### PLANNING AND ZONING COMMISSION CALLED SPECIAL SESSION AGENDA

Wednesday, October 16, 2019	6:00 p.m.	Manor City Hall – Council Chambers 105 E. Eggleston Street

# PRELIMINARY PLANS FOR MANOR HEIGHTS PHASE 2 SECTION 1 & PHASE 2 SECTION 2 CITY OF MANOR, TRAVIS COUNTY, TEXAS

The first submittal of the Manor Heights Phase 2 Preliminary Plan (*Preliminary Plan*) submitted by Kimley-Horn and received on July 18, 2019, have been reviewed for compliance with the City of Manor Subdivision Ordinance 263B.

## Major Roadway ROW Exhibit

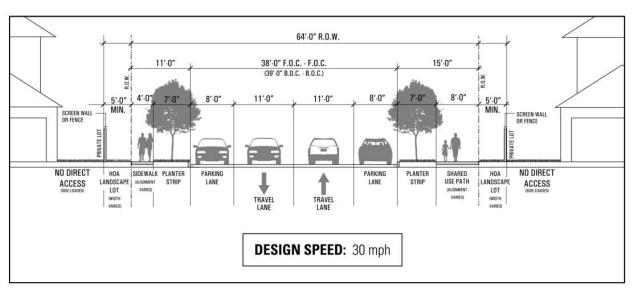
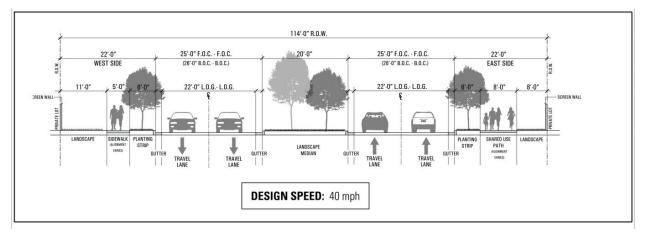
13. Our office has reviewed the revised waiver request submitted on March 18, 2019 and subsequent submittals made on April 10-11, 2019. Calculations submitted as part of the request included a proposed curve number value of 93 for major roadway areas. The established USDA Natural Resources Conservation Service NRCS curve number for paved street areas with curb or gutter section is 98. Provide updated calculations using the established curve number of 98 for major roadway areas. Use of an alternative curve number for major roadways is not permitted unless supporting calculations for a less conservative CN value are reviewed and approved.

**Response:** Please see the attached Major Roadway ROW Exhibit. This exhibit includes curve number calculations for the major roadway ROW for each Basin. The calculations were performed based on major roadway typical cross sections also included in the exhibit. The maximum CN value calculated is 92.8; therefore, the CN value used for Major Roadway ROW of 93 is conservative.

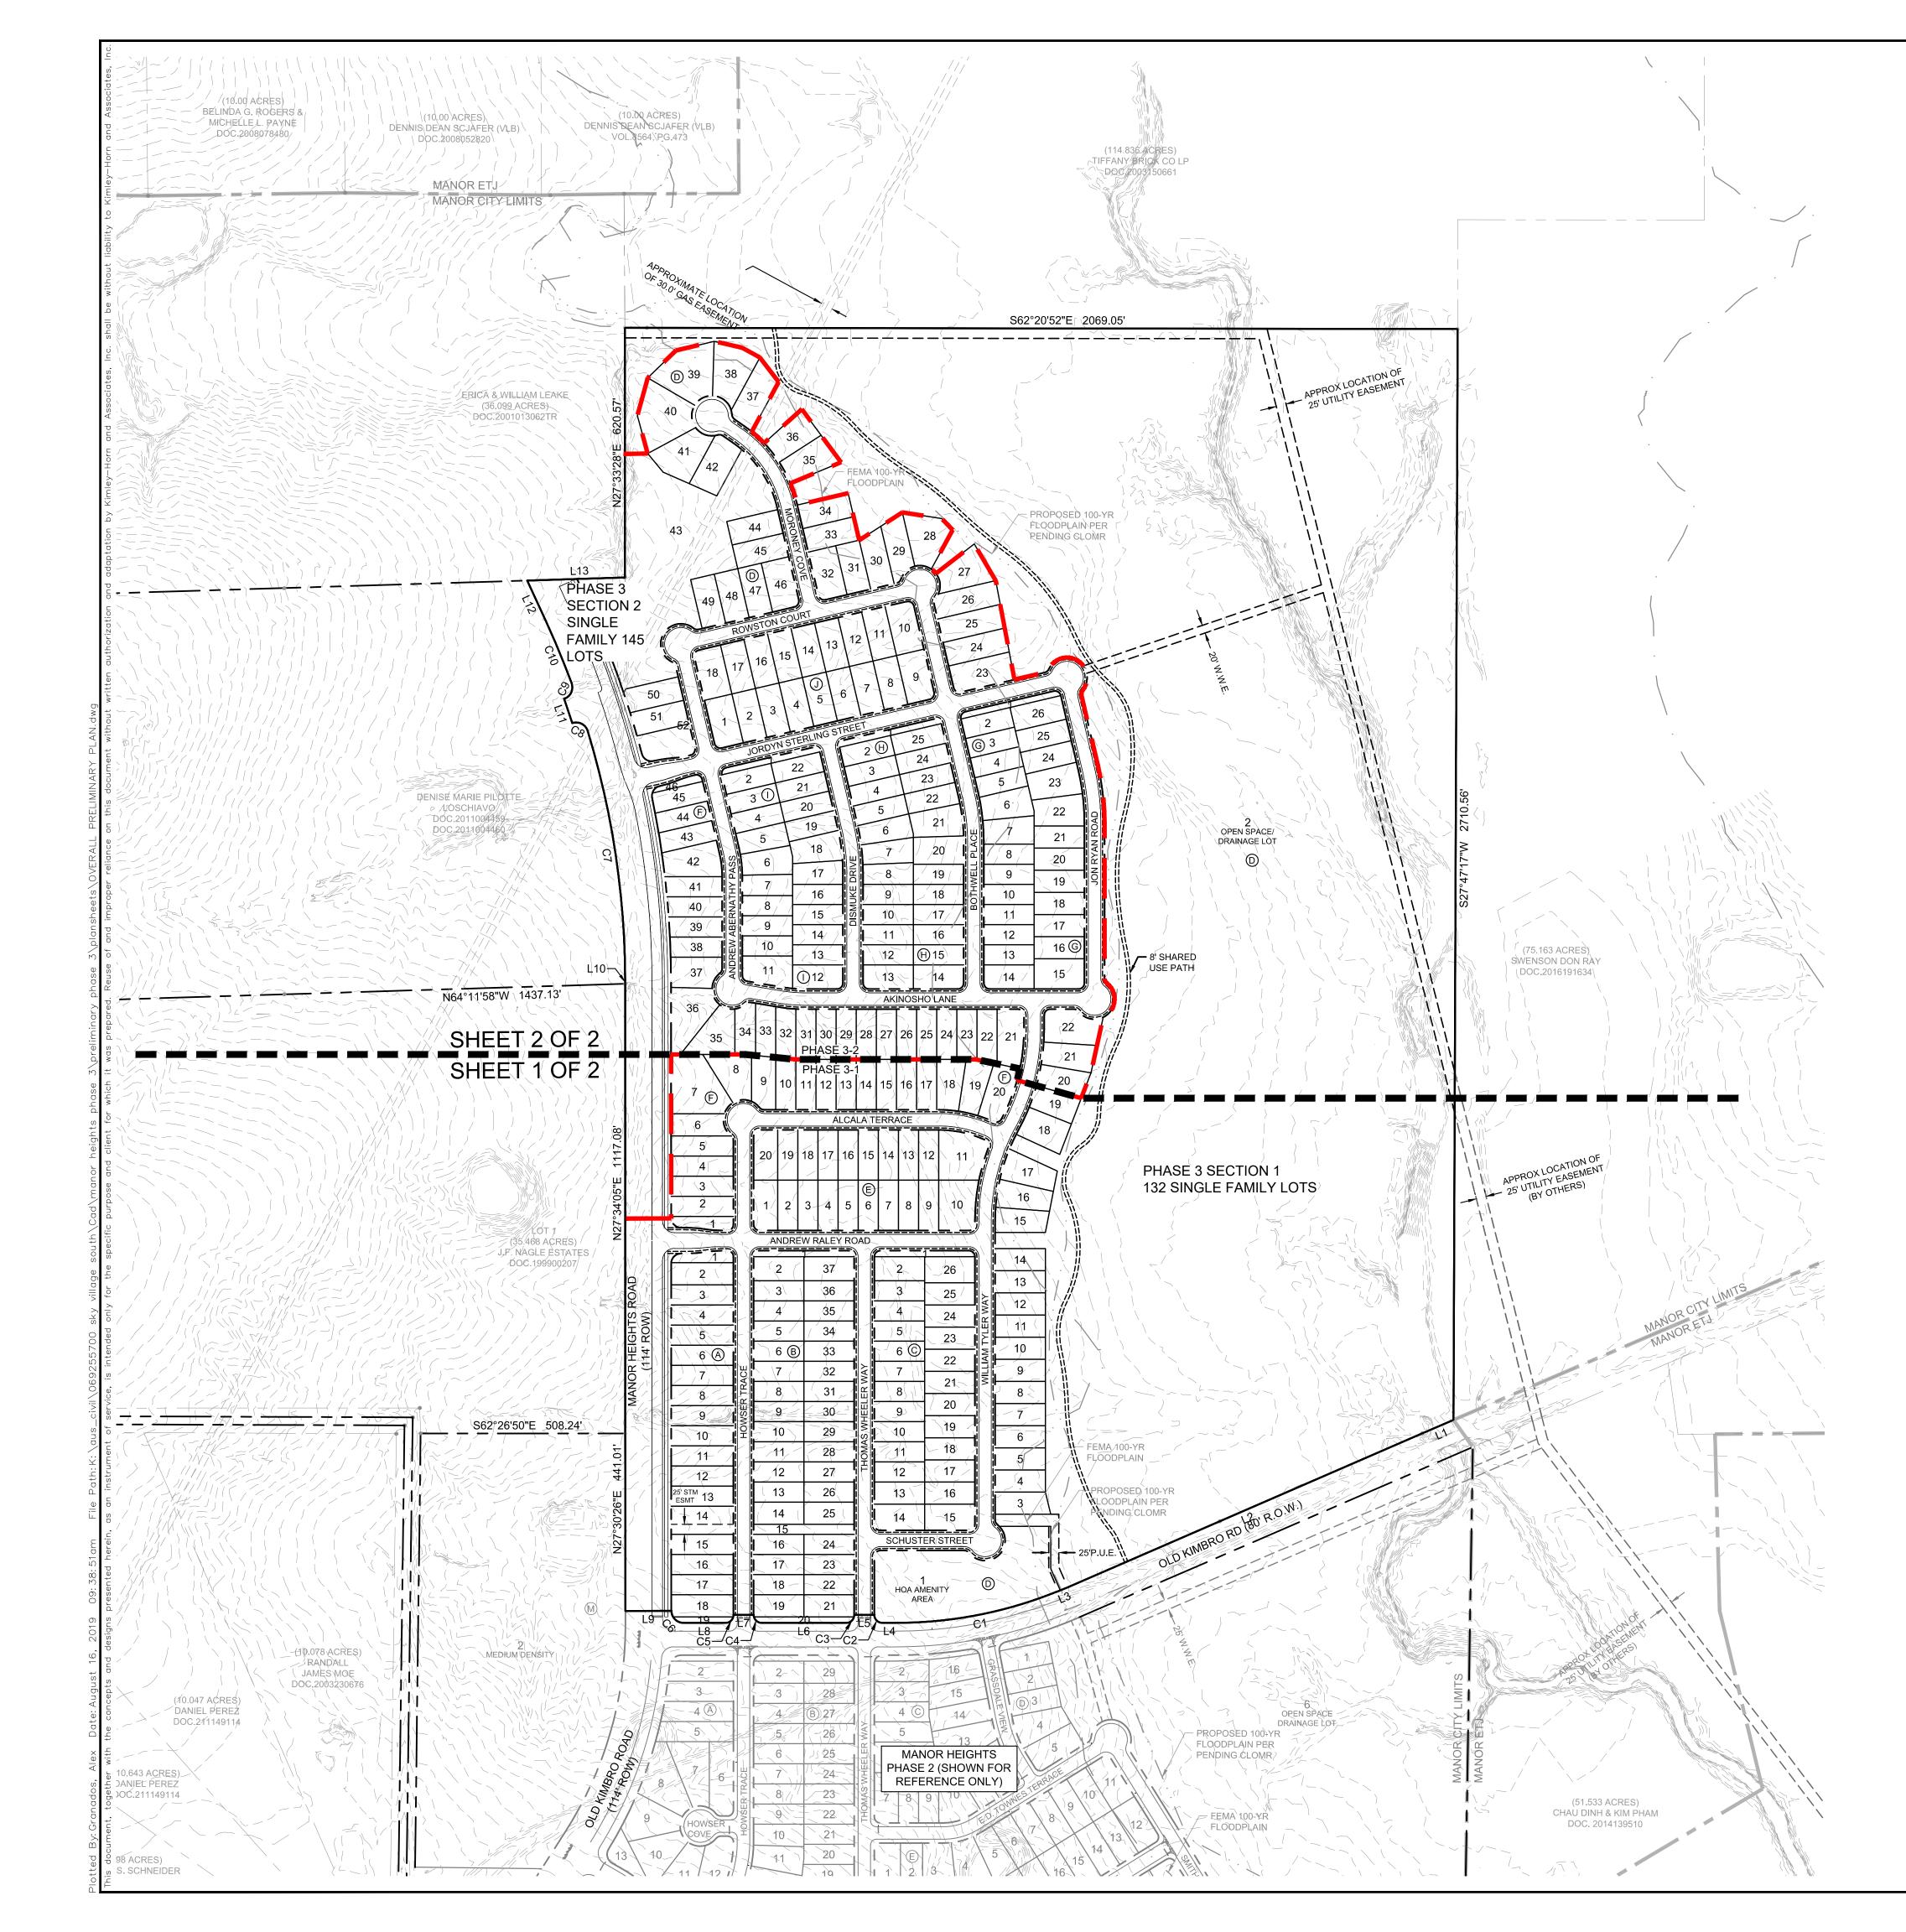
8. On Sheet 3 there is a 25' wide STM easement shown on Lot 14 Block A whereas on Block B there is Lot 15 that appears to be for drainage. Why wouldn't Block A have the same set up?

8. On Sheet 3 there is a 25' wide STM easement shown on Lot 14 Block A whereas on Block B there is Lot 15 that appears to be for drainage. Why wouldn't Block A have the same set up?

Response: Total Acreage of Open Space/Floodplain (73.61 AC) is now shown on the Sheet 3.

Response: Total Acreage of Open Space/Floodplain (74.02 AC) is now shown on the Sheet 3 which exceeds what was shown (73.05 AC) on the development agreement Exhibit F, and proposed parkland is also shown on Sheet 3 (3.05 AC) which exceeds the acreage shown on the development agreement Exhibit F (2.8 AC).
